Re. Response to Council further information requests for the resource consents for EB3C and EB4L Application Packages

The Eastern Busway Alliance (EBA) on behalf of Auckland Transport are writing in response to Auckland Council's (the Council) request for further information dated 17th October 2023 for the resource consents for Eastern Busway 3 Commercial (EB3C) and Eastern Busway 4 Link (EB4L). The relevant resource consent reference numbers are as follows:

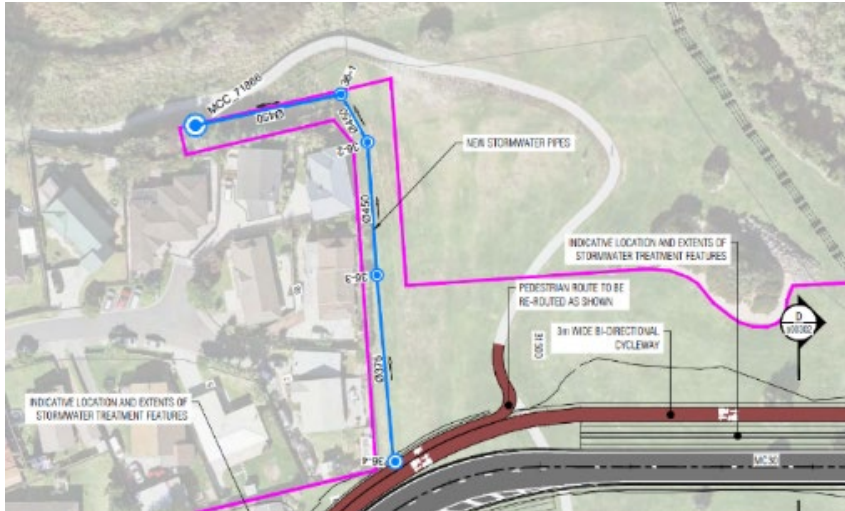
18. *Figures 6-1 to 6-4 includes a circle showing the 10m setback and 100m setback from the wetlands. However, for outfalls MCC_108481 and bridge works the 10m setback circle does not clearly show all works proposed within this setback. Furthermore, the 100m setback should be represented as 100m setback when measured from the edge of each wetland. Please amend the 10m setbacks to be a linear line to better clarify what works will be undertaken within this setback. Please amend the 100m setback to clearly identify proposed works within this setback.*

Having regard to outfall MCC_108481, this outfall is not being upgraded as part of the Project. The extent of works in this location relates to a pipe upgrade which finishes at manhole MCC-7186 (refer snip from the General Arrangement drawings below). Figure 6-1 in the Terrestrial and Freshwater Ecological Effects Assessment shows the location of existing outfall MCC_108481 for information purposes only. This may have led to a misunderstanding around the extent of works in this location.

We have updated the drawings (refer **Attachment 2**) to show the extent of the construction footprint relative to the pipe upgrade and the NES: FW 10m and 100m setbacks.

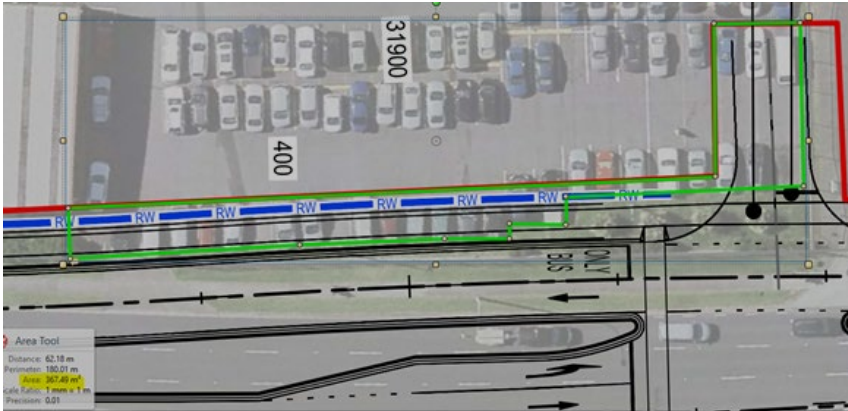
27. To confirm whether HCGC or High use Road consents are required under E9, please provide:

The stormwater from roads and the busway are proposed to be discharged via the Healthy Waters Regionwide Stormwater Network Discharge Consent (NDC) (some catchments via existing outlets, and via upgraded outlets and some via new outlets). This approach has been agreed with Healthy Waters for the entire Eastern Busway project area. We draw your attention to the Stormwater Effects Assessment attached as Appendix 11 to the EB3C/EB4L NoR/resource consent applications. In particular section 3.3 of this Assessment sets out an overview of NDC connection requirements and the category (3 & 4) that applies to the Project. Under the NDC Auckland Transport projects are covered under a special section in schedule 4, which outlines connection requirements. EB3C falls under Category 3 which covers new/development of impervious areas of existing high use roads greater than 1000m² and other roads that include new impervious areas greater than 5,000m². EB4L falls under Category 2 - *“off pedestrian and cycling facilities and new impervious area greater than 1000m².”*

The proposed EB3C works does modify Tī Rākau Drive. Ti Rakau Drive meets the definition of ‘high use road’. However, the busway itself is not a ‘high use road’ with only approximately 700 bus movements a day. Burswood Drive is also a ‘high use road’ with approximately 5,230 vehicle movements a day. The busway intersects with Burswood Drive at two locations. EB3C includes new or redevelopment of impervious carriageway area greater than 1,000 m² on high use roads (Tī Rākau Drive and Burswood Drive), and/or areas greater than 5,000 m² on other roads (the busway falls under this definition). Therefore, EB3C is within the scope of Category 3 (individual and combined) of Schedule 4 connection requirements for the NDC.
